**Accessibility Site Survey of Selected Items
For
Title 24 of the California Building Code**

Crescendo Charter School/Conservatory
4900 South Western Avenue
Los Angeles, CA 90062

January 27, 2010

Restroom

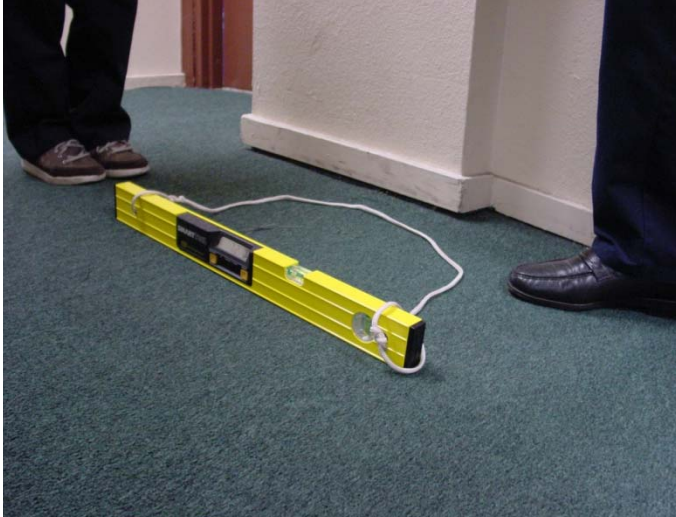
No signage
Door swings in
No 60 inches of clear space
